marantz® SERVICE BULLETIN		Date: 15-Jan.-2007	Model: ST6001/N1B/N1S
		Page: 1 / 1	REF.NBR: MZ07-001
Level		Application:	
★ ★		See Below	
		Subject: FL Segment Light Leakage	
		Int.ref:

[PHENOMENON]

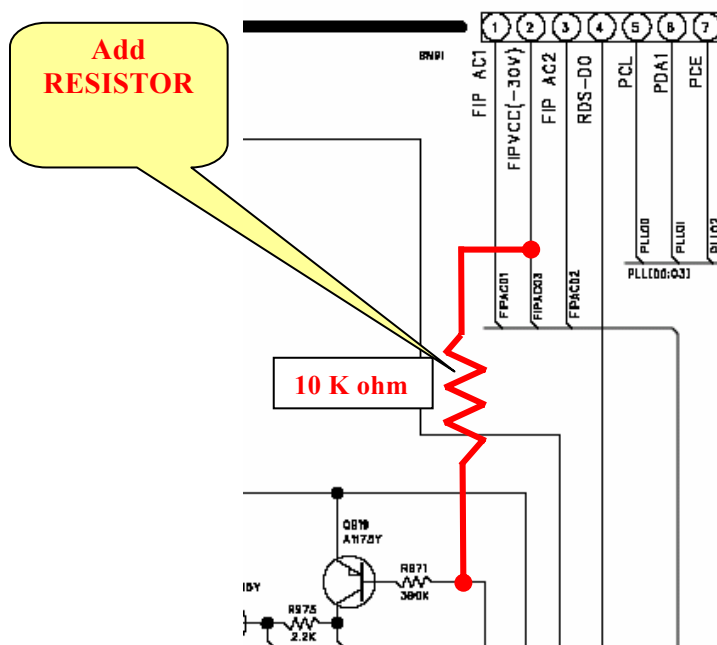
Due to variability in their performance quality of the component, the FL Displays of certain ST6001 units develop light leakage in the left segment when the indicator lights up.

Light Leakage

[SOLUTION]

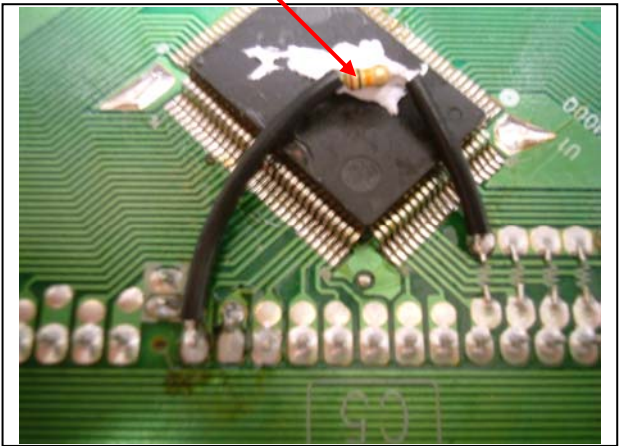
1. Circuit rectification, Add the RESISTOR to FRONT PWB.

10 K ohm

POS.NO	PART NO.	Description
-	00MGD05103160	RESISTOR 10k OHM +-5% 1/6W
